Engineering Review

**FINAL DRAINAGE REPORT
FOR
RETREAT AT TIMBERRIDGE
FILING NO. 2**

PCD-ENGINEERING REVIEW COMMENTS
IN BLUE BOXES WITH BLUE TEXT

*CCES
Responses in
Red*

RETREAT AT TIMBERIDGE FILING NO. 1
CONSTRUCTION PLANS
HEC-RAS ANALYSIS
CHANNEL STATIONING EXHIBIT

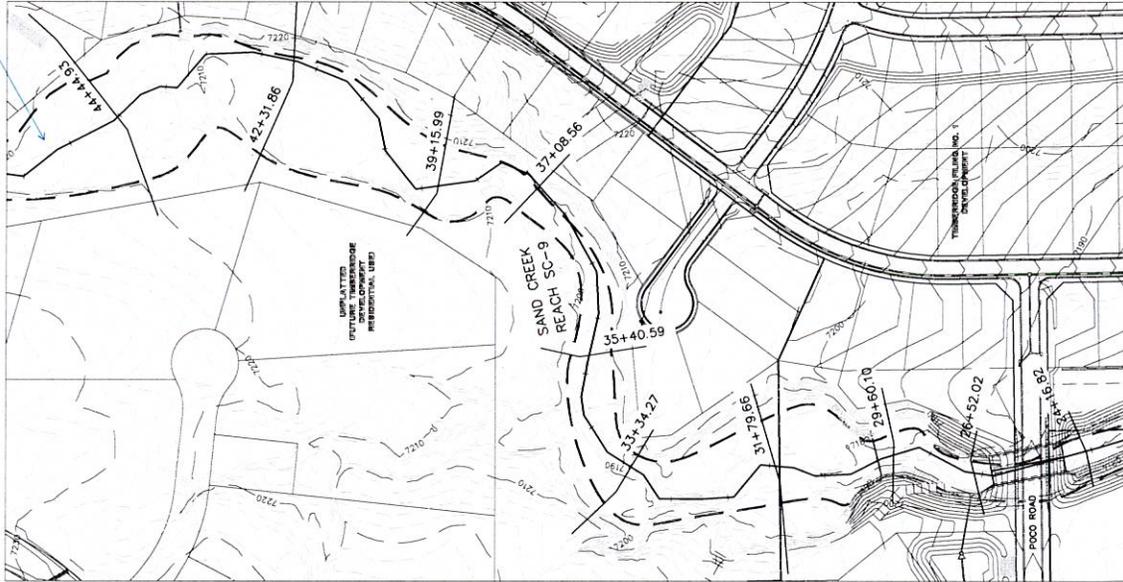
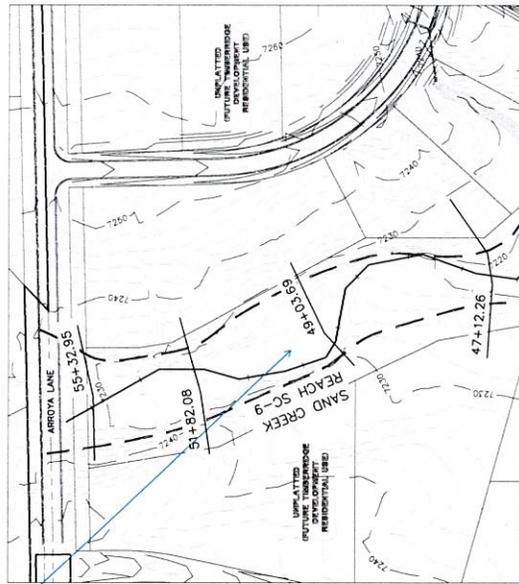
Please add the FEMA water level elevation lines.

see revision

TIMBERRIDGE PR rev1 Plan: SC PR 2/12/2020

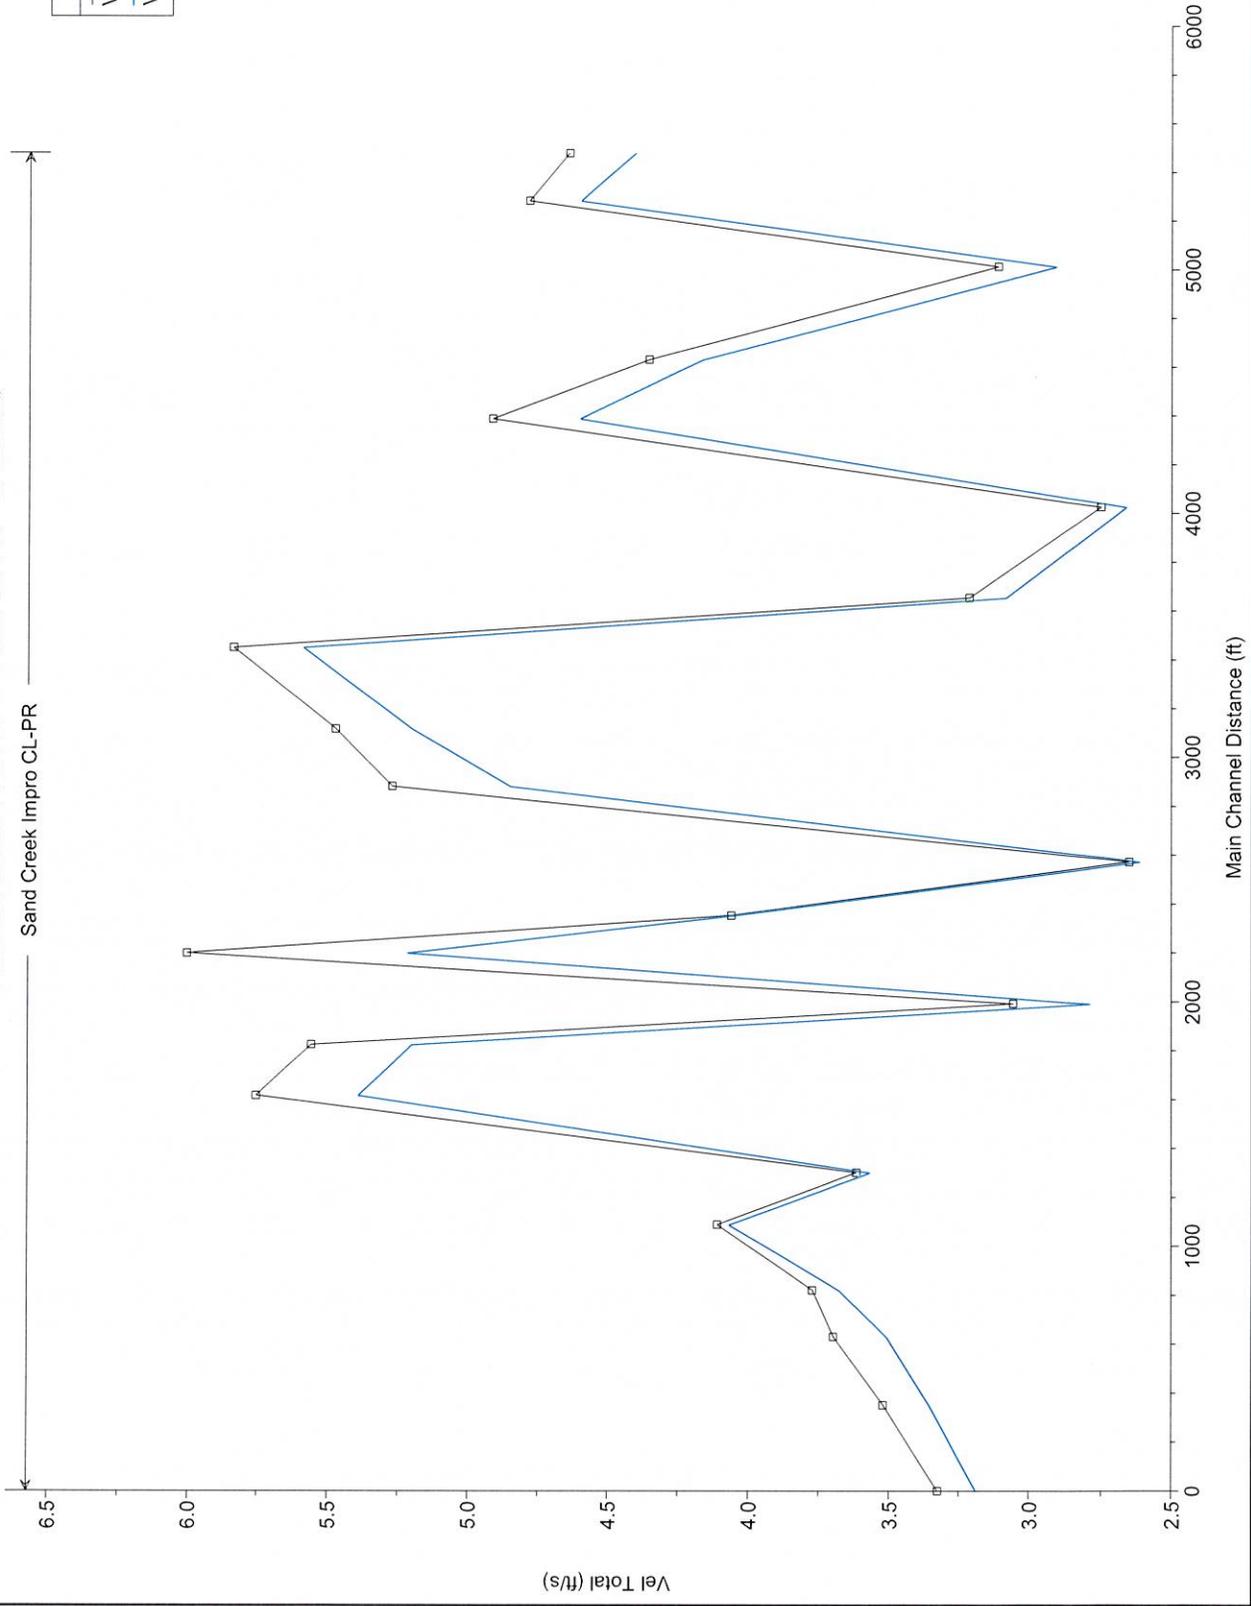
Please highlight
the cross-sections
within and
adjacent to this
plat.
